Notice of change in ground roller assembly for urethane saddle

Subject	Notice of change in ground roller assembly for urethane saddle	Date of issue	April 24, 2020
		MITSUBISHI ELECTRIC FA INDUSTRIAL PRODUCTS CORPORATION 1-1-1 Imajuku-Higashi, Nishi-ku, Fukuoka 819-0192 TEL 092-805-3631

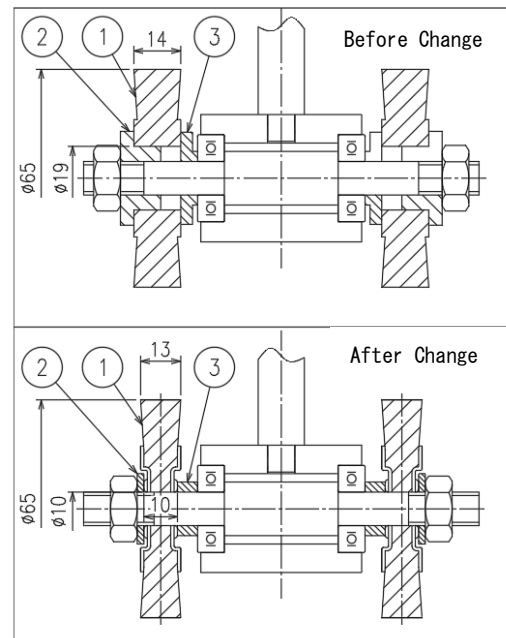
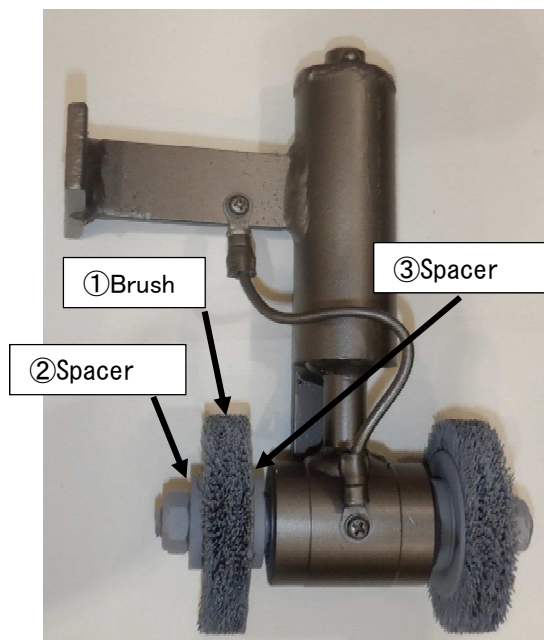
Change in brush part of ground roller assembly for urethane saddle.

Due to its compatibility, the ground roller assembly, part code (03N13W) is remain unchanged for after change has been made.

The shape of the spacer will be changed according to change in brush dimensions.

No mounting compatibility is available for brush part when before and after following changes have been made.
